City of Mississauga Department Comments

Date Finalized: 2023-07-05 File(s): A207.23 Ward: 1

Property Address: 856 Atwater Ave

Appendix 1 – Transportation and Works Comments

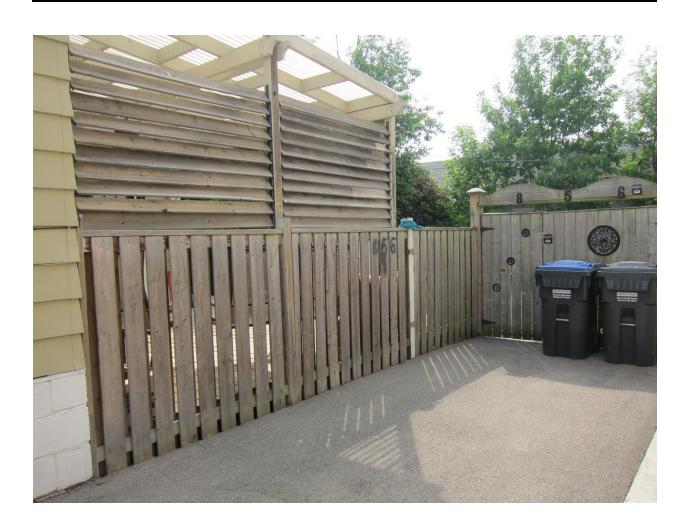
We are noting for Committee's information that any Transportation and Works Department concerns/requirements for the proposed garages will be addressed by our Development Construction Section through the future Building Permit process. We advise that the proposed driveway is to include a curb along the right edge in order to stop the surface drainage to flow onto the neighboring property and direct it out to the front of the lot.
